File #: 2019-4711

Application of APC Contractors, Inc. c/o Miles Hanford & Tallant, LLC to rezone property from R-75 (Residential Medium Lot-75) to RSM (Residential Small Lot Mix) for a 36-unit single-family attached townhome development at a density of 7.3 units per acre, at 2061 & 2067 Windyhill Road.

STAFF ANALYSIS

Case No.: Z-10-1243617 **Agenda #:** N. 5

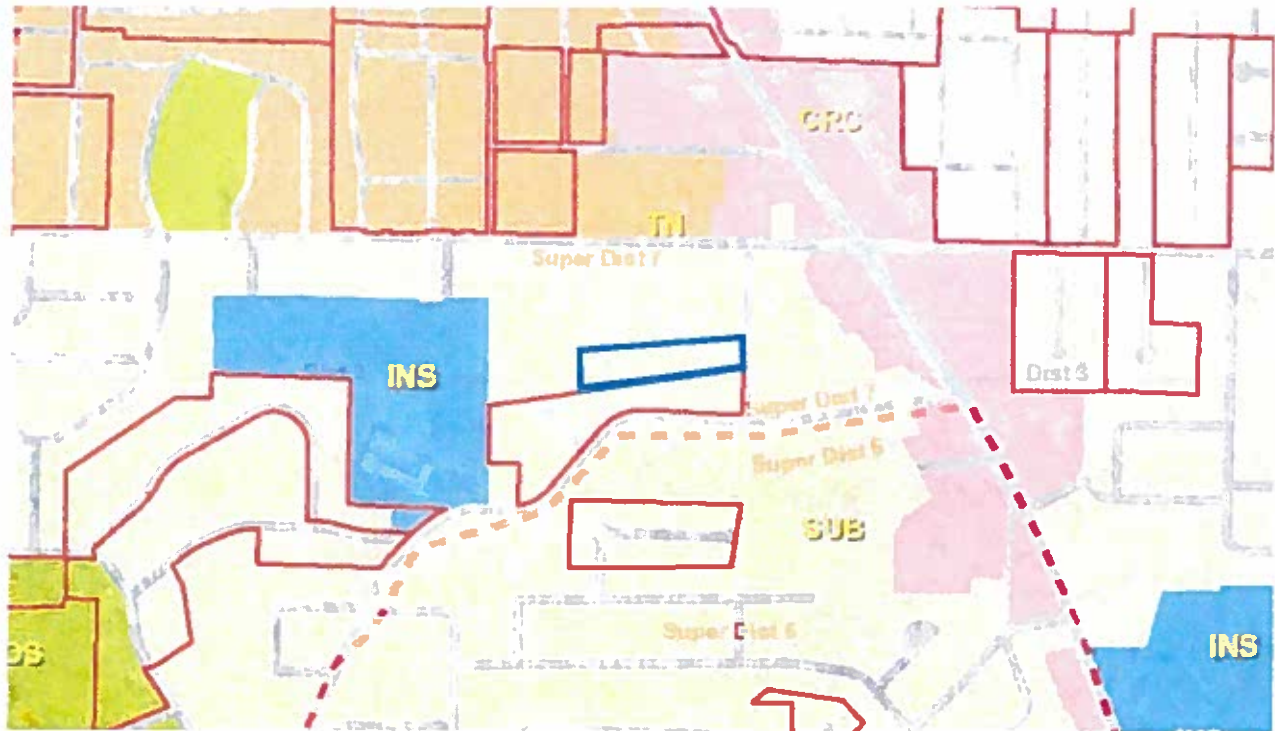
RSM STANDARD		REQUIRED/ALLOWED	PROVIDED/PROPOSED	COMPLIANCE
MAX. D.U.s/ACRE		Base: 4; with bonuses: up to 8 d.u.s/acre	7.3 units/acre	No
DENSITY BONUSES		Proximity to amenities, provision of off-site improvements, EarthCraft construction, increased enhanced open space, etc.	The proposal does not have features that would qualify for density bonuses.	No
MIN. OPEN SPACE /ENHANCED OPEN SPACE (Applicable if project is > 5 ac. or ≥ 36 d.u.s)		Not applicable.	Not applicable.	N.A.
MIN. LOT AREA		1,000 square feet	Information not provided.	Not provided.
MIN. LOT WIDTH		25 feet	32 feet	Yes
MAX. LOT COVERAGE		70% of total parcel acreage	Information not provided.	Not provided.
MIN. BLDG. SETBACKS	FRONT	20 feet	25 feet	Yes
	INTERIOR SIDE	Not applicable.	Not applicable.	N.A.
	SIDE – CORNER LOT	Not applicable.	Not applicable.	N.A.
	REAR W/O ALLEY	15 ft.	30-64 feet. 20 feet of the rear yards are used for the required 20-foot transitional buffer.	Yes

BUILDING SPACING		Min. 3 ft with fire rating or min. 7 ft. w/out fire rating & no windows (ICC Code)	Units 14-19: 5 ft. Other units: 10-20 ft.	Units 14-19 must be fire-rated.

MINIMUM UNIT SIZE	1,200 square feet	2,400 square feet	Yes
MAX. BLDG. HEIGHT	35 feet	34 feet	Yes
MIN. STREETScape DIMENSIONS - PROPERTY FRONTAGE	6-ft. landscape strip, 6-ft. sidewalk, street trees 30 ft. on center	3-foot sidewalk, 8-foot landscape strip shown on ½ of the frontage, street trees not shown.	The site plan must comply or an administrative variance will be necessary.
MIN. STREETScape DIMENSIONS - PRIVATE DRIVES	5-ft. landscape strip and 5-ft. sidewalk on each side; street trees every 50 feet	3-foot sidewalk, 3-foot landscape strip, street trees not shown.	The site plan must comply or an administrative variance will be necessary.
TRANSITIONAL BUFFERS	20-ft. buffer & screening fence required along north and south property lines	20-foot buffers; screening fence not shown.	The site plan must comply or an administrative waiver will be necessary.
PARKING	Min. 1.75 spaces/unit; max 3.25 spaces/unit	2 garage spaces & 1 driveway space	Yes
